Snowy 2.0 Main Works Modification 1

Main Access Tunnel to Marica Services Connection
State Significant Infrastructure Modification Assessment
(SSI-9687-Mod-1)

Published by the NSW Department of Planning and Environment

Figure 3 | Drill pad site layout (Source: Modification Report)

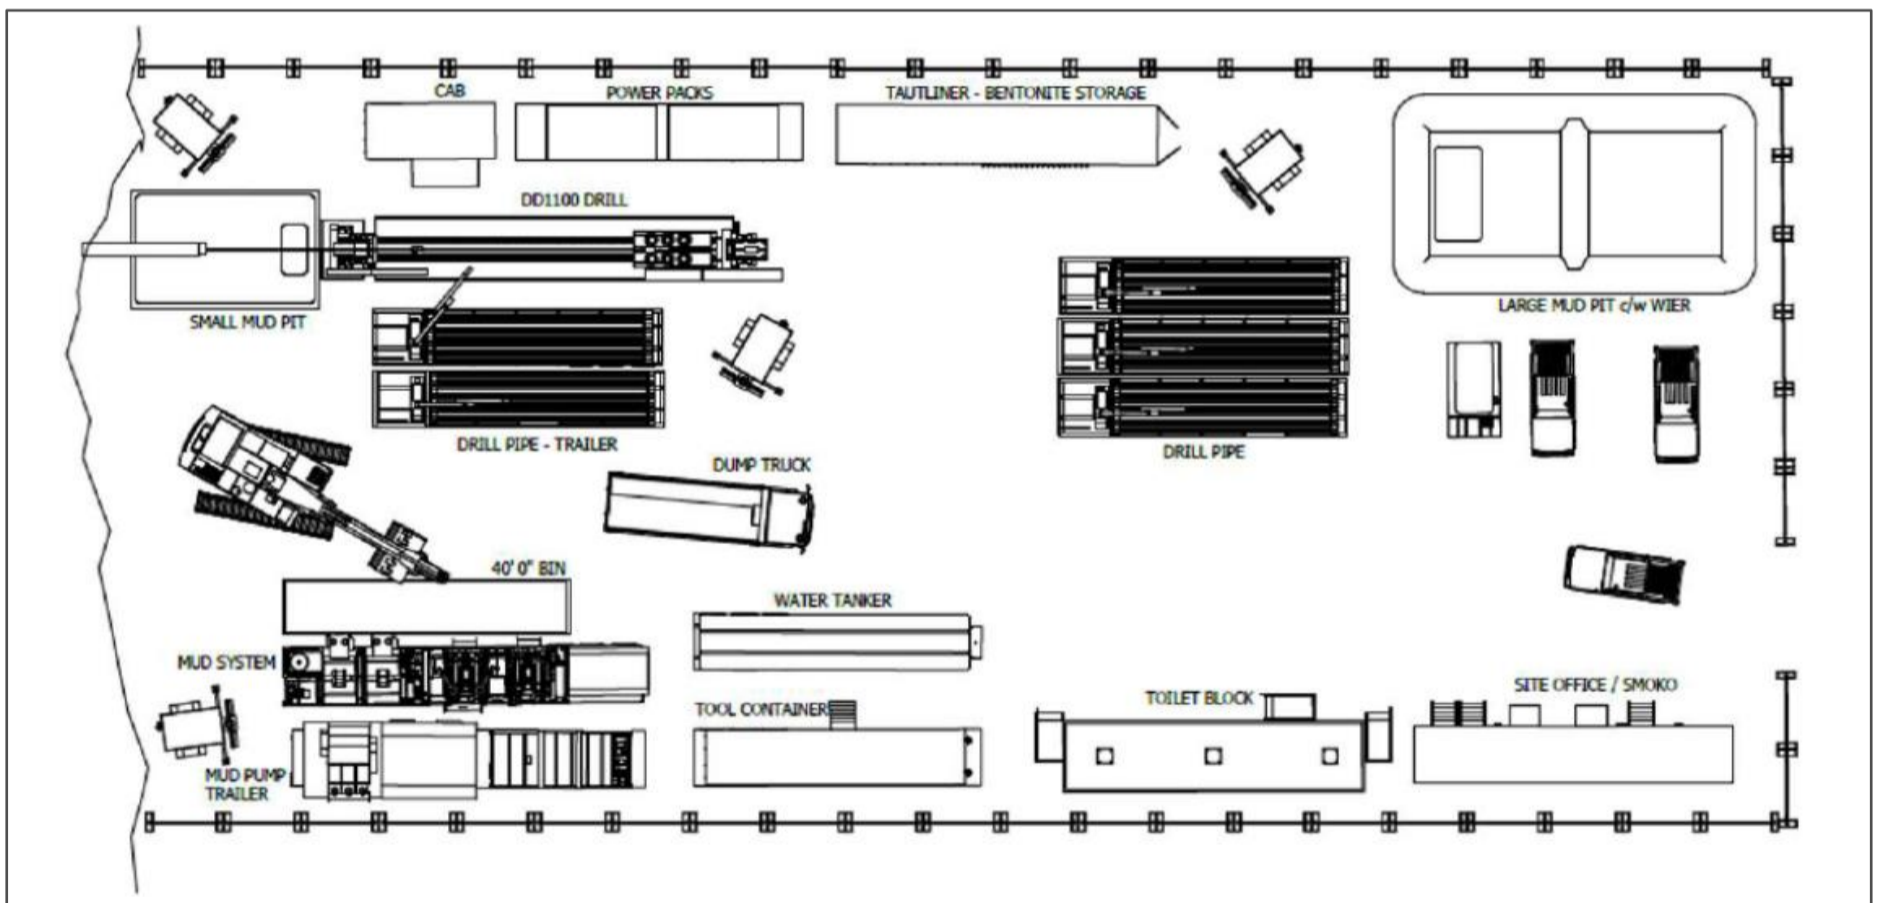
- increasing the footprint of the eastern receival pad (Marica) site to 100 m x 100 m (from 100 m x 40 m).
- stating the proposal would use only water-based substances for drilling fluid.
- confirming the length of drilling to be 2.28 km (increased from 2.2 km).
